Access Compliance Report

Public Rights-of-Way

(Curb Ramps)

Intersection ID: 24277	Main Street: CHINA GROVE CHURCH RD	Cross Street: DENDY LN	Location:	NE
ADA ID: AB5DE4A3CC48	Ramp Type: Perp	Initial Pass/Fail: Pass	Overall Compliance: No	Severity Score: 7.5
Codes/Mitigation Info/Possible Solution		Field Measurements/Component Compliance

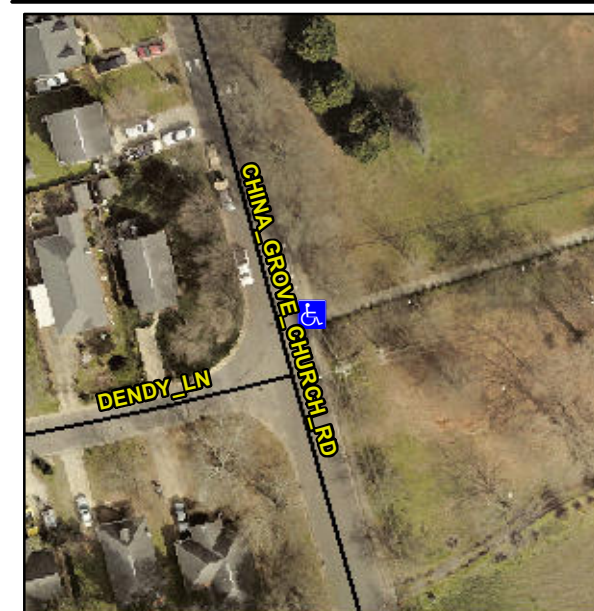
Surveyor Notes:

N/A

**Not Found, R304.2.2-Perp, R304.3.2-
Para, R302.7.2, R304.5.3**

**Remove & Replace Entire Ramp.
Remove & Replace Gutter.**
